LANDSCAPE CONSTRUCTION PLANS
FOR

TUSCARORA PARK AT VENTANA RANCH WEST

SET #
DATE: 2/26/07
FINAL FOR CONSTRUCTION
TUSCARORA PARK

CITY OF ALBUQUERQUE change order 1-3-07 ve options	
TITLE: TUSCARORA PARK AT VENTANA RANCH WEST CONSTRUCTION AND LAYOUT PLAN/DETAILS	
DESIGN REVIEW COMMITTEE	CITY ENGINEER APPROVAL
LAST DESIGN UPDATE	MO./DAY/YR.
CITY PROJECT NO.	ZONE MAP NO.
778882	B-8-2
SHEET	OF
REPLACES SHEET 3 OF 7

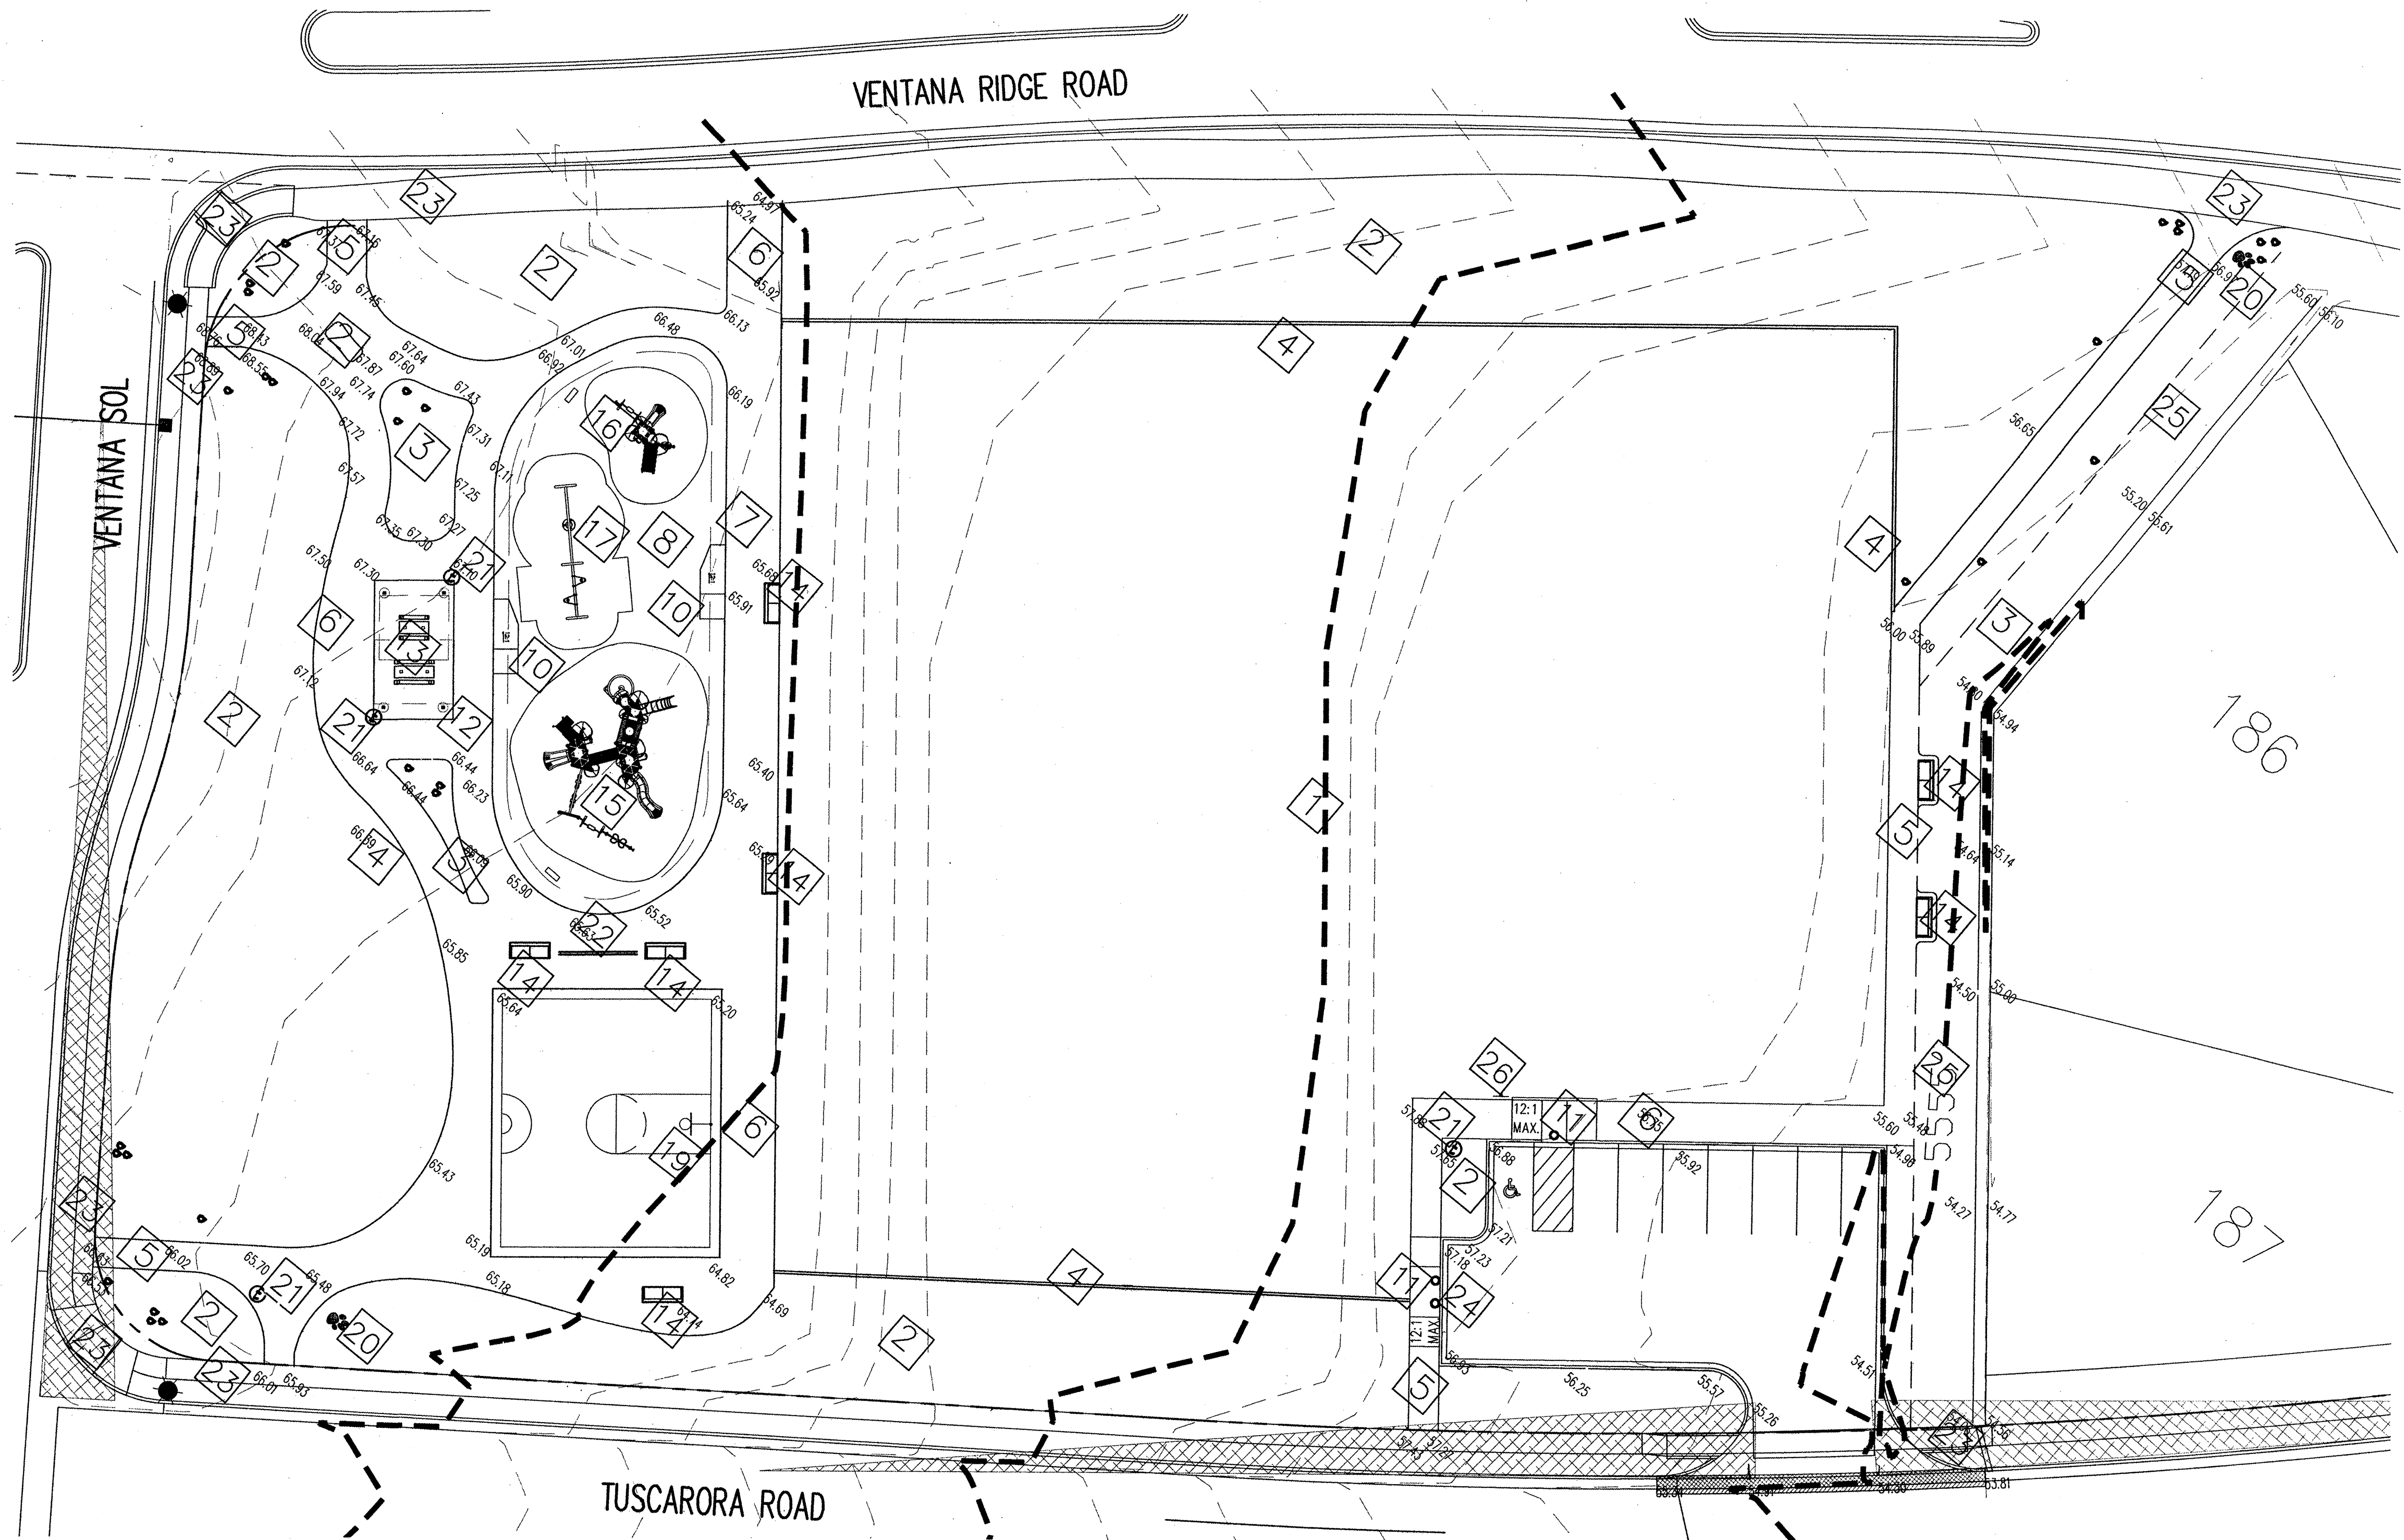
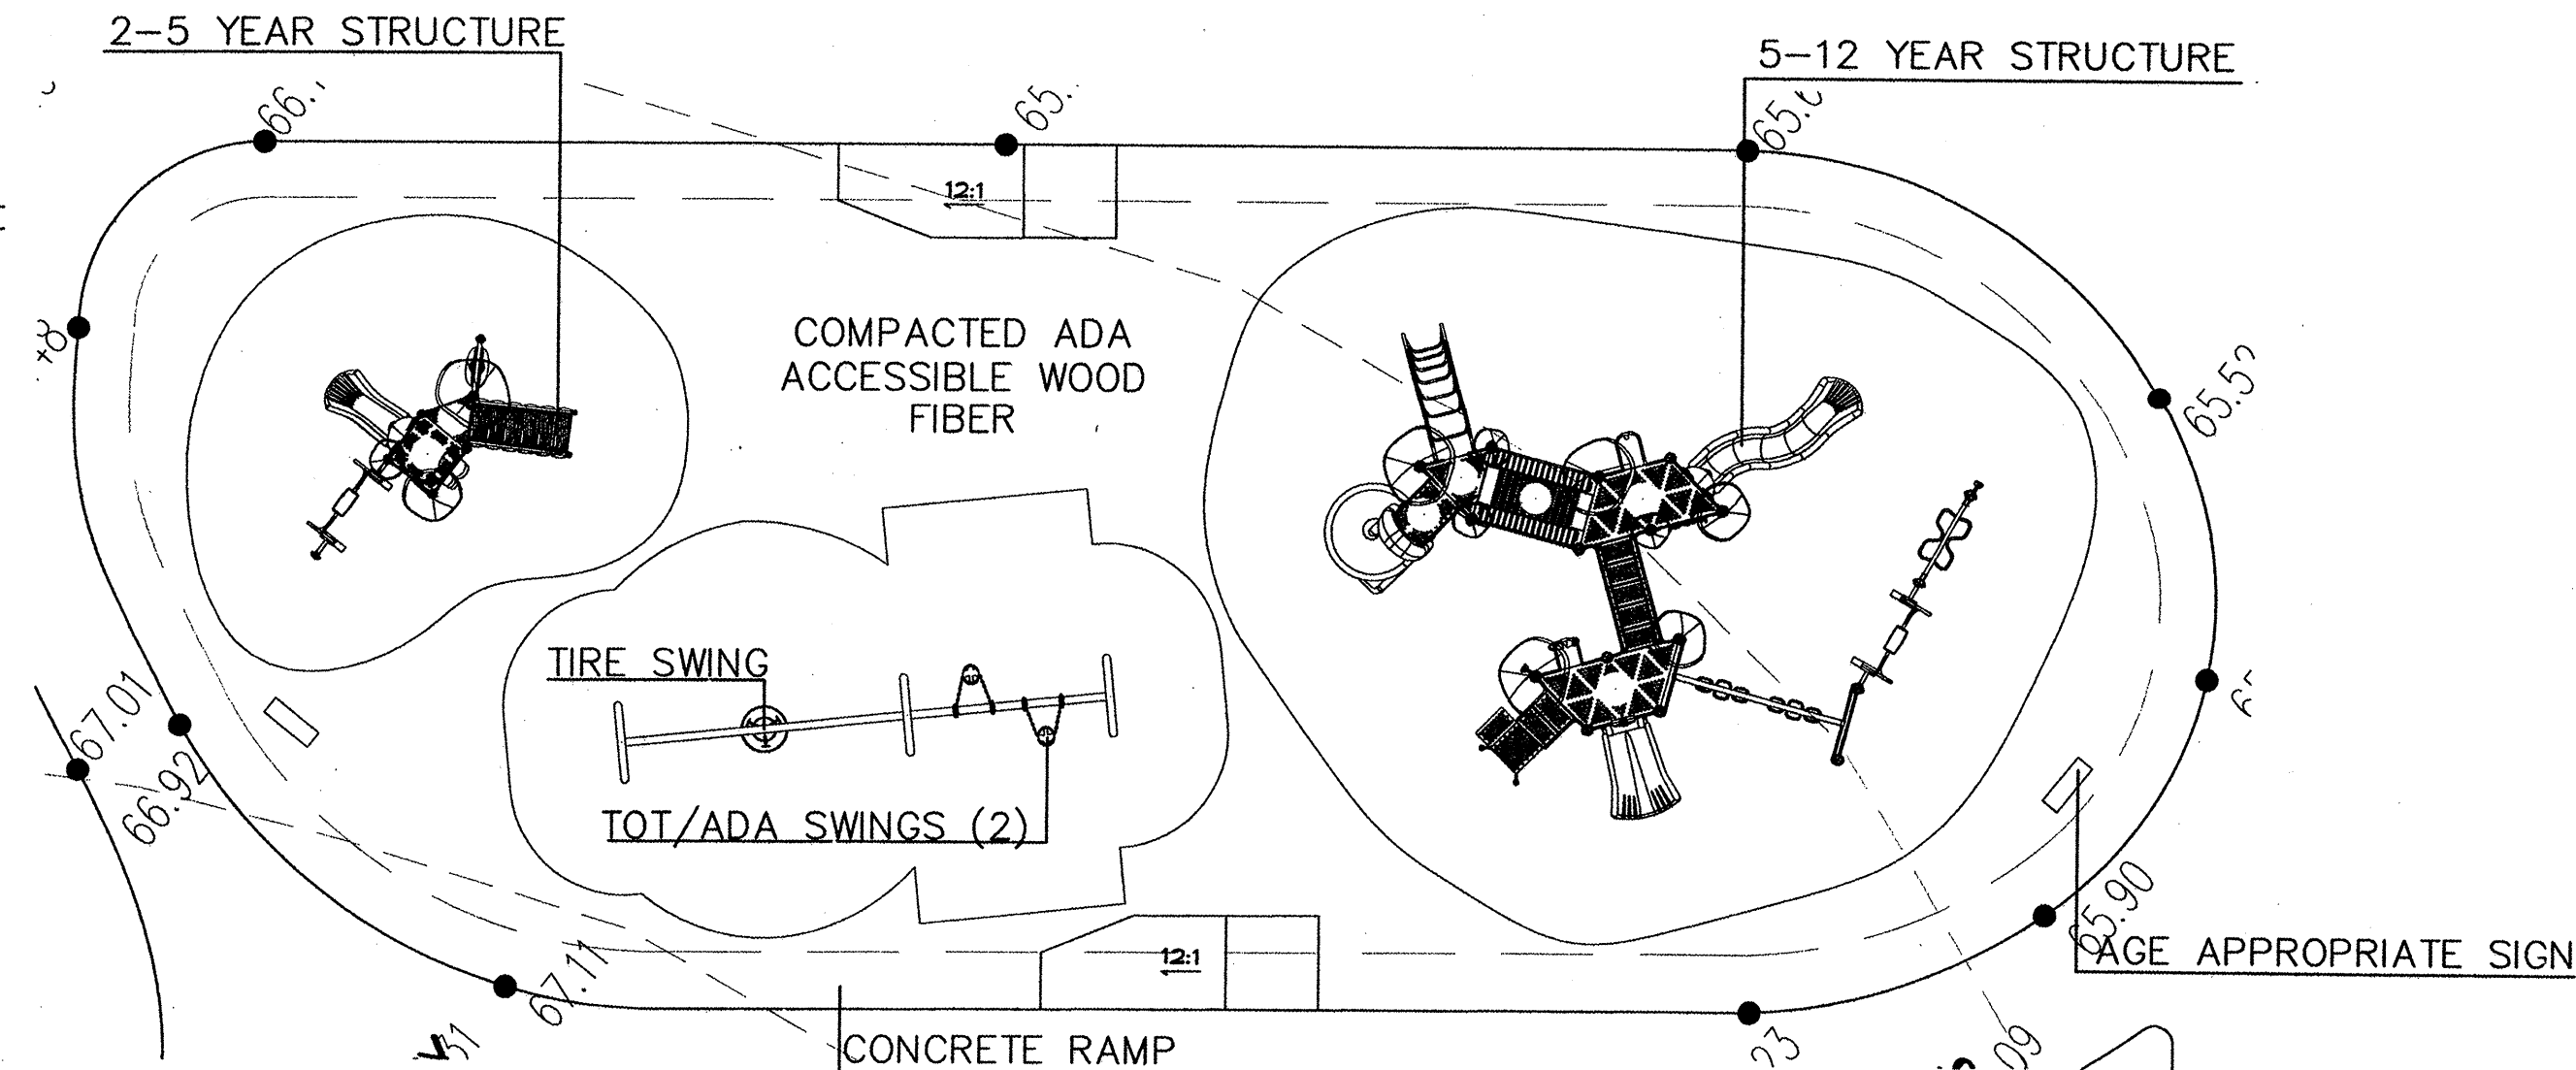
- 13 ~~TABLE (1 HC Accessible) MODEL NO. APT/CW-6PC (2) APT/CW-8PC (1) SURFACE MOUNT :R.J. THOMAS MFG. CO. CEDAR COLORED REC.PLASTIC AND BROWN POWDER COAT~~

- 14 ~~HC ACCESSIBLE BENCH (1) WITH ARM RESTS ON SIDES AND MIDDLE- MODEL NO. PWRB/CW-6PC SURFACE MOUNT :R.J. THOMAS MFG. CO. CEDAR COLORED REC. PLASTIC AND BROWN POWDER COAT~~

- 17 SWING COMBO (TIRE/ARCH W/TOTS)PLAYWORLD MODEL NO. 500/500
- 18 ~~SOFTFORM ANIMALS- BY ROCKBLOCKS AND BOULDERS- (MODEL NO. FISH, DOG AND FROG) (NO FALL ZONE) GREY GRANITE COLOR~~

change order- ve options-removed all soft form animals, removed 6 benches & 3 tables, added 1 trash, concrete area	1-3-07
PER DRC COMMENTS	11/7/08
REMARKS	NO. DATE
DESIGNED BY	CJ
DRAWN BY	CJ
CHECKED BY	JD
DATE	XXXX
DATE	XXXX
DATE	XXXX
